SUBJECT: North Shore Connector
NSC Train Systems (System Wide)
Contract No. NSC-009

ADDENDUM NO. 2

August 11, 2008

CHANGES TO NSC-009 CONTRACT DRAWINGS (VOLUME 1)
(Modified or Added Drawings are attached here to)

PORT AUTHORITY OF ALLEGHENY COUNTY PITTSBURGH, PENNSYLVANIA	NORTH SHORE CONNECTOR NSC TRAIN SYSTEM (SYSTEM WIDE) TYPICAL TRACK SECTIONS PLINTH ANCHOR DETAILS
Port Authority	CONTRACT NO. NSC-009 DWG NO. TK132A SHT. 11A

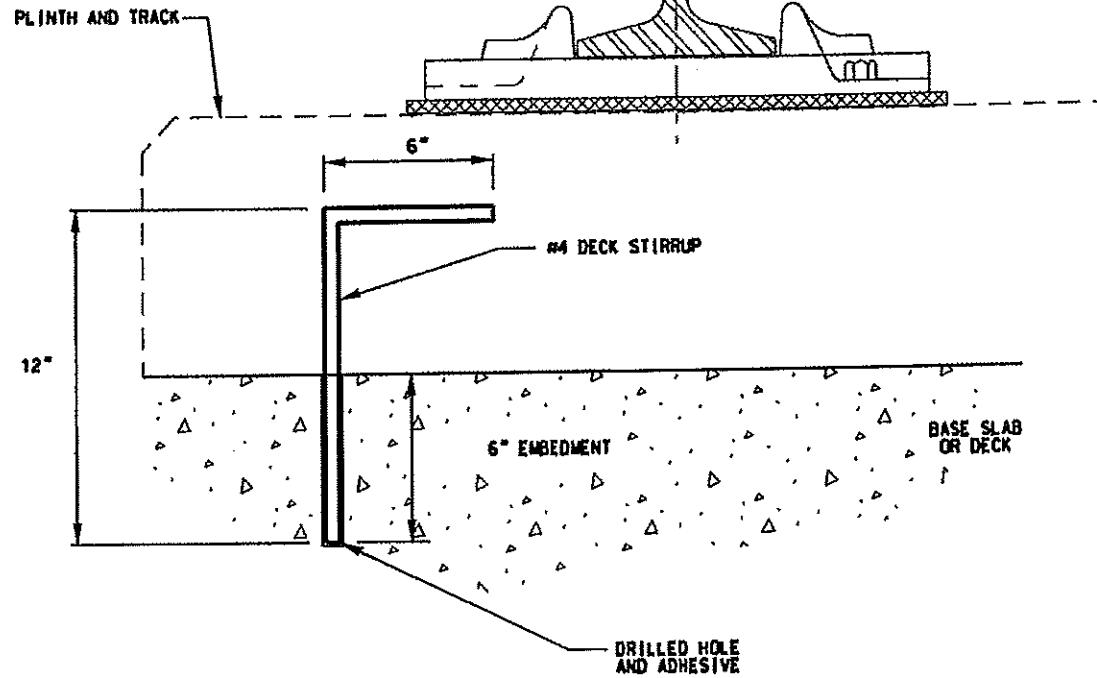
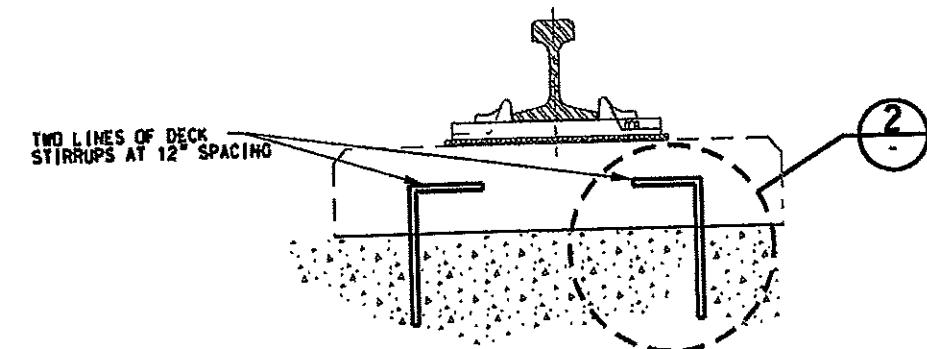
1. Drawing No. TK132A, Sheet No. 114A. Drawing Modified.
2. Drawing No. CR100, Sheet No. 563. Drawing Modified.
3. Drawing No. CR101, Sheet No. 564. Drawing Modified.
4. Drawing No. CR104, Sheet No. 567. Drawing Modified.
5. Drawing No. CR105, Sheet No. 568. Drawing Modified.

NO.	DATE	DESCRIPTION	REVISIONS
8/05/08	ADDENDUM 2 - DRAWING MODIFIED

PORT AUTHORITY OF ALLEGHENY COUNTY
PENNSYLVANIA
NORTH SHORE CONNECTOR
NSC TRAIN SYSTEM (SYSTEM WIDE)
ELECTRICAL CABLE ROUTING PLAN
GATEWAY STATION TO TUNNEL
Port Authority
CONTRACT NO. NSC-009
DWG. NO. CR101 SHT. 564

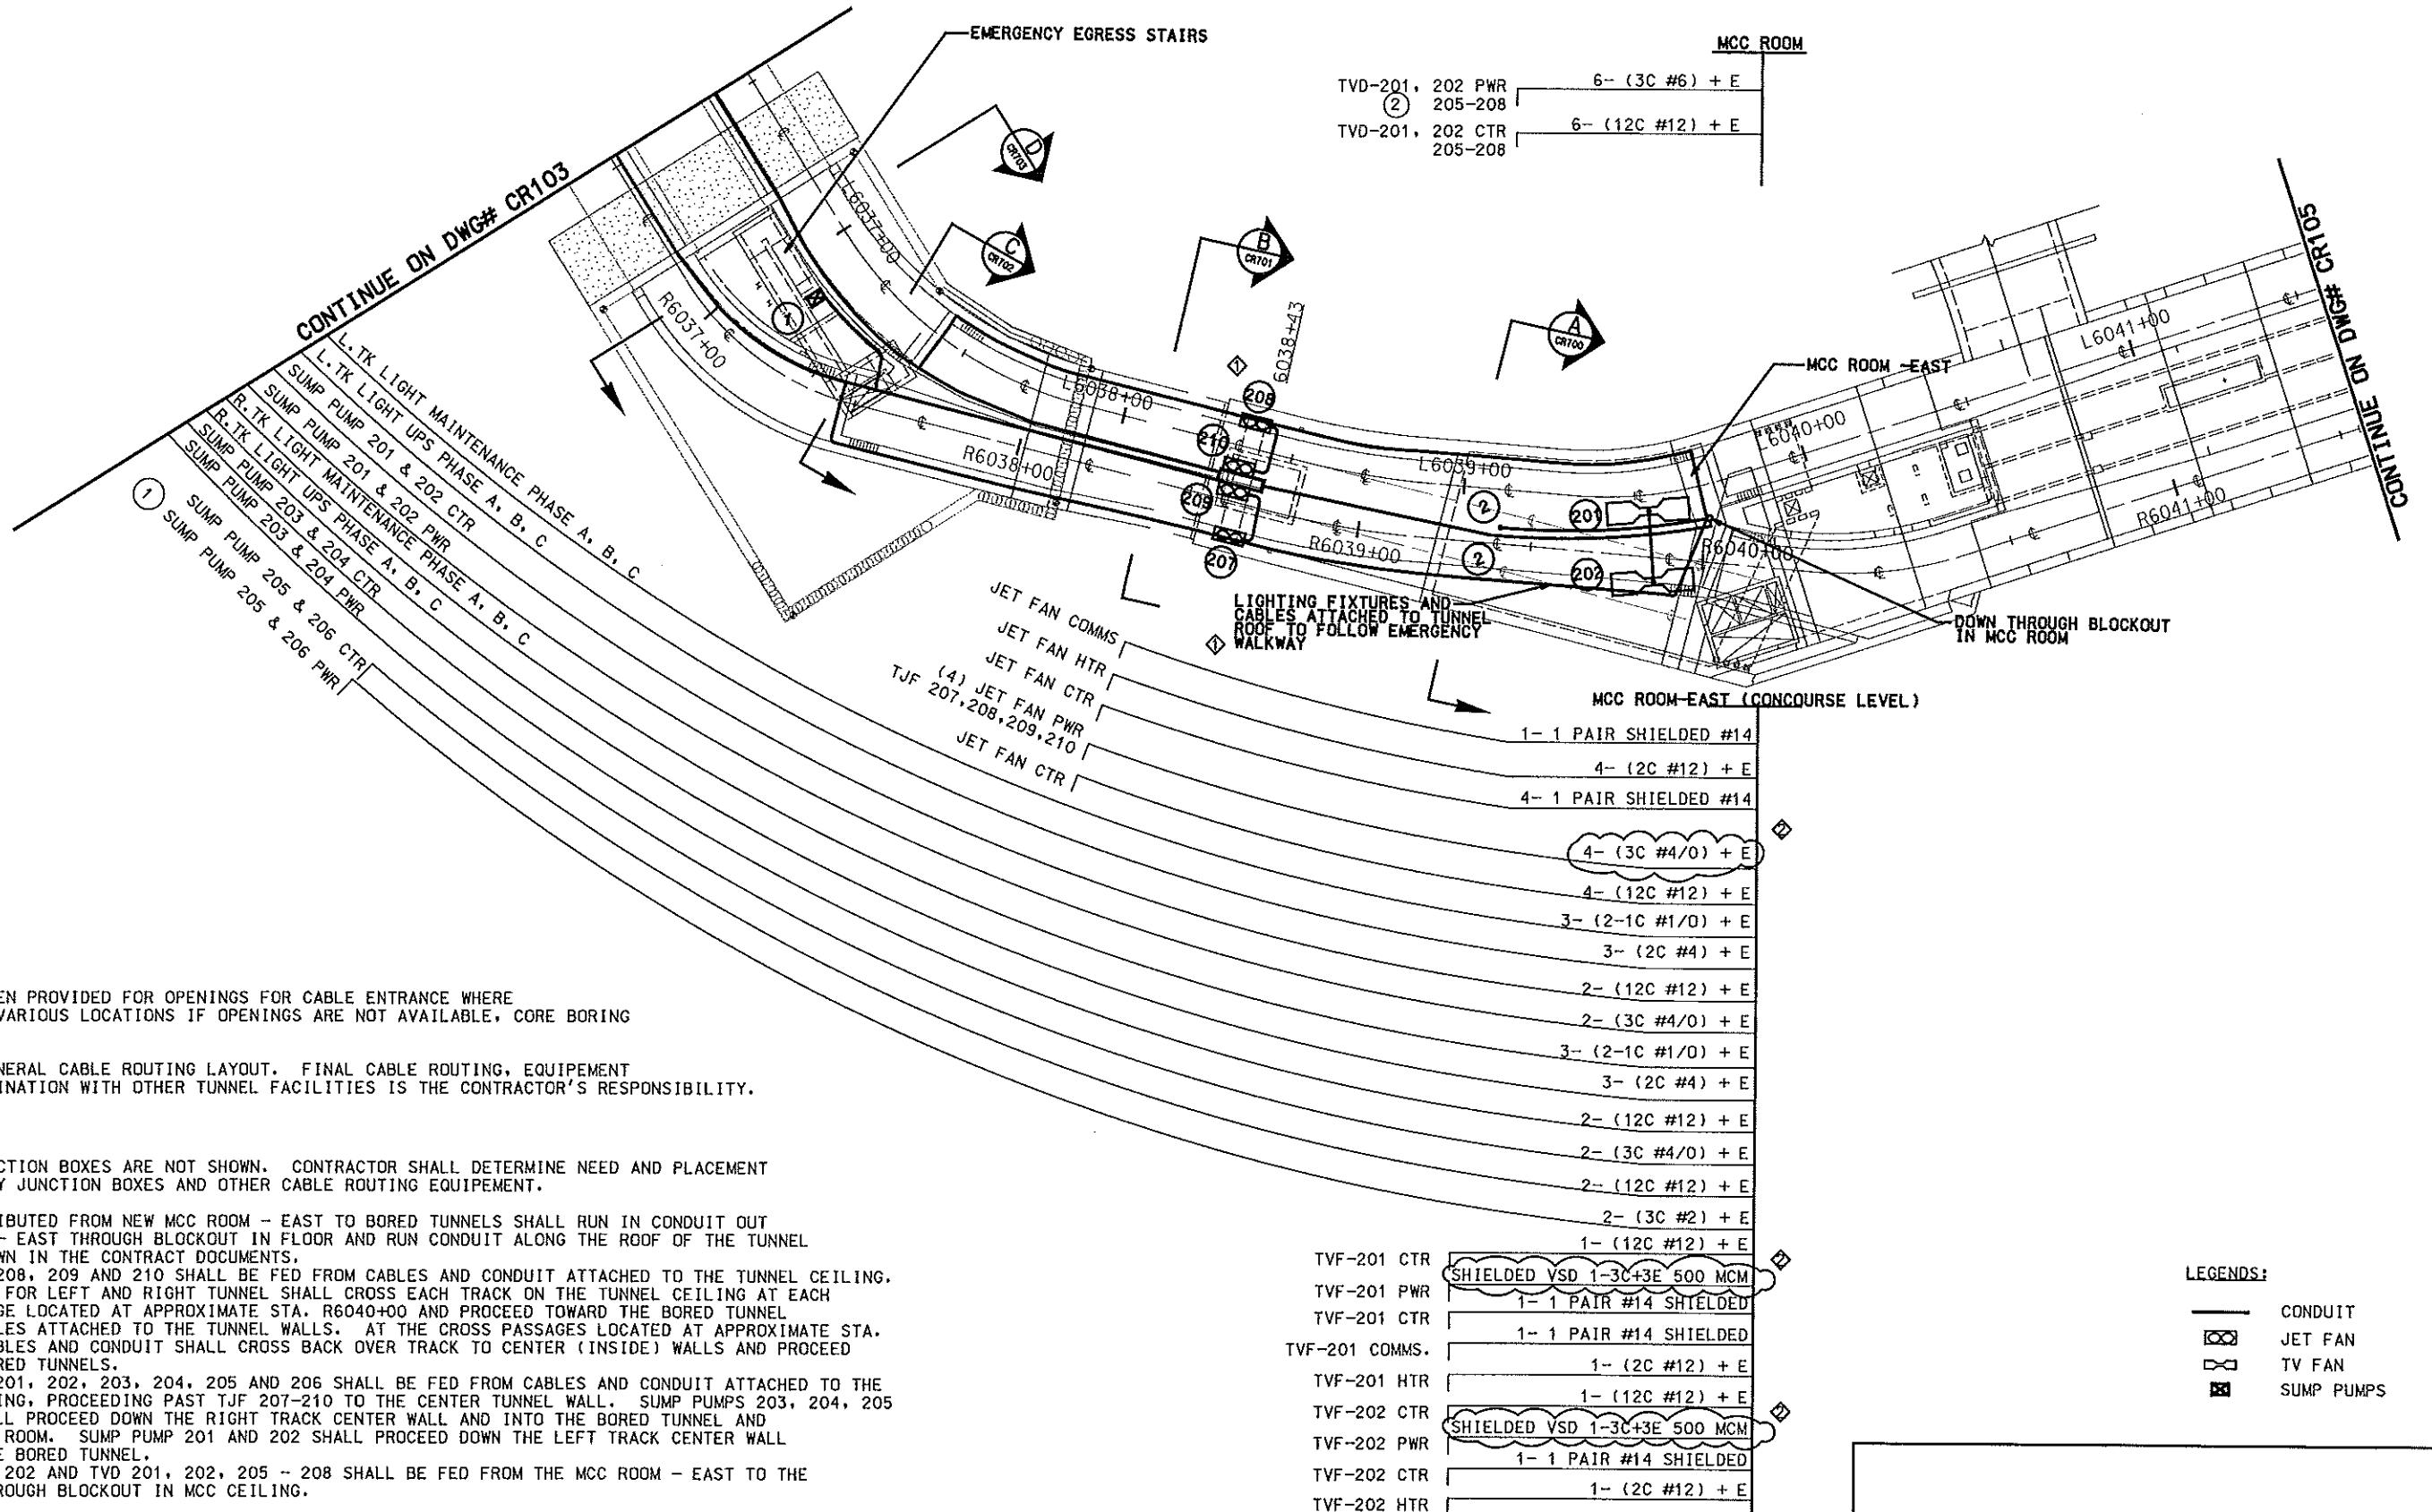
NO.	DATE	DESCRIPTION	REVISIONS
3/5/08		ADDENDUM 2 - DRAWING MODIFIED	
7/31/08		ADDENDUM 1 - DRAWING MODIFIED
